CAUI-4 C2C transmitter equalization, feedback, and MDIO control

(In support of comment #i-9)

Cl 83D	SC 83D.3.1.1	P 154	L 4	# i-9
RAN, ADEE		Intel Corporation		
Comment Type	T	Comment Status	X	
<p>The current method for setting the transmitter equalization coefficient is unidirectional. There is no standardized method for a receiver to indicate whether the current transmitter equalization coefficients are good or not, or to request a change to the coefficients in use. Configuring a multi-port system without such methods is difficult if at all possible.</p> <p>Using a back channel for transmitter equalization tuning as in Clause 72 is a powerful feature. Since CAUI-4 does not use the clause 72 training, to avoid adding complexity it is suggested to add an optional back-channel through MDIO control.</p> <p>Having a standardized MDIO-based method will help multi-port systems integration and tuning and promote interoperability.</p> <p><i>SuggestedRemedy</i> A proposal was discussed in the CAUI-4 ad hoc. Presentation and detailed text, tables and figure will be supplied.</p> <p><i>Proposed Response</i> <i>Response Status</i> O</p>

Figure 83D-5 depicts the components of the CAUI-4 chip-to-chip link and the registers used during the tuning procedure.

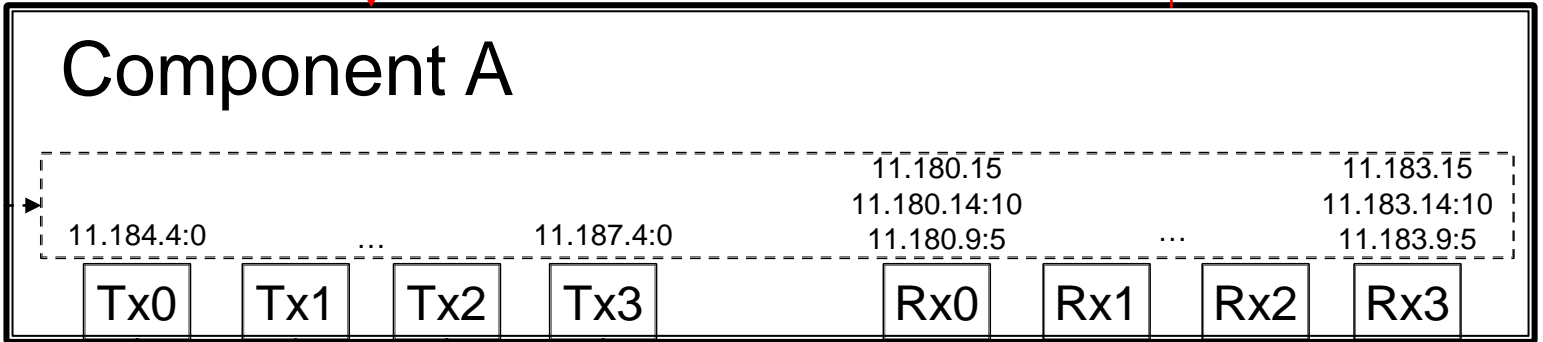
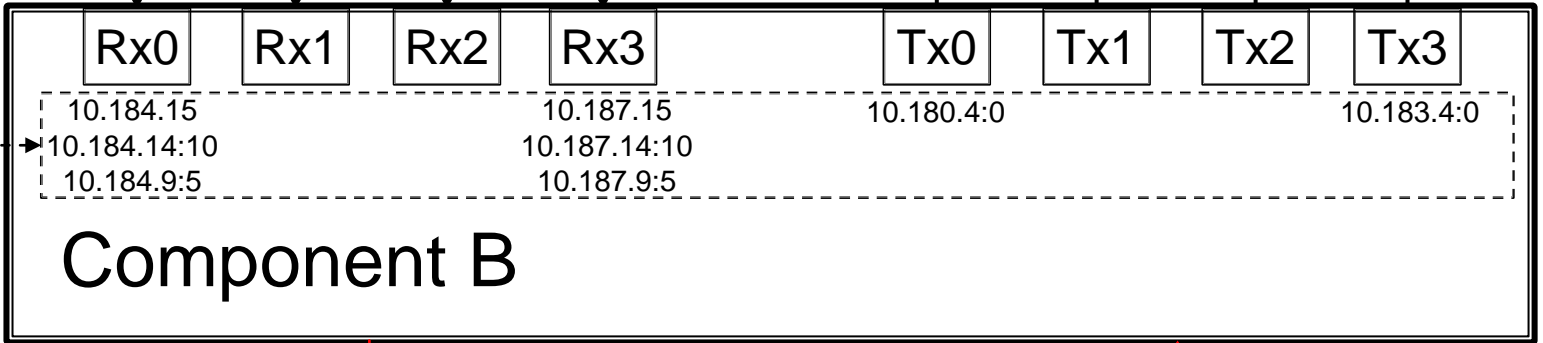
If implemented, transmitter equalization feedback from a CAUI-4 chip-to-chip receiver may be used to tune the equalization settings of the transmitter at the other end of the CAUI-4 chip-to-chip link to the values requested by the receiver. An example of a possible transmitter equalization tuning process using transmitter equalization feedback is provided in this subclause.

In this example, two components, A and B, are connected by a CAUI-4 chip-to-chip link, such that A is closest to the PCS and B is closest to the PMD. Clause 45 MDIO is implemented by both components, with component A at device address 11 and component B at device address 10. Transmitter equalization feedback is implemented by either component A, component B, or both. One Station Management (STA) controls both components.

The STA performs the procedures described in 83D.5.2 and 83D.5.3 to tune lane 0 equalization settings in both sides of the CAUI-4 chip-to-chip link. When these procedures are completed, the STA uses similar procedures to tune equalization settings in lanes 1 through 3. When all lanes are tuned, the STA may repeat the process with another pair of components connected by CAUI-4 chip-to-chip.

1. Read Local_eq_cm1 (11.184.1:0) and Local_eq_c1 (11.184.4:2) from component A.
2. Write Local_eq_cm1 and Local_eq_c1 read from component A to Remote_eq_cm1 (10.184.6:5) and Remote_eq_c1 (10.184.9:7), respectively, in component B.
3. Read Request_flag (10.184.15), Requested_eq_cm1 (10.184.11:10) and Requested_eq_c1 (10.184.14:12) from component B.
4. If Request_flag is 0, go to tuning equalization settings on lane 0 in the Receive direction (83D.5.3)
5. If Request_flag is 1, write Requested_eq_cm1 and Requested_eq_c1 read from component B to Local_eq_cm1 (11.184.1:0) and Local_eq_c1 (11.184.4:2), respectively, in component A.
6. Go to step 1.

1. Read Local_eq_cm1 (10.180.1:0) and Local_eq_c1 (10.180.4:2) from component B.
2. Write Local_eq_cm1 and Local_eq_c1 read from component B to Remote_eq_cm1 (11.180.6:5) and Remote_eq_c1 (11.180.9:7), respectively, in component A.
3. Read Request_flag (11.180.15), Requested_eq_cm1 (11.180.11:10) and Requested_eq_c1 (11.180.14:12) from component A.
4. If Request_flag is 0, proceed to tuning lane 1.
5. If Request_flag is 1, write Requested_eq_cm1 and Requested_eq_c1 read from component A to Local_eq_cm1 (10.180.1:0) and Local_eq_c1 (10.180.4:2), respectively, in component B.
6. Go to step 1.
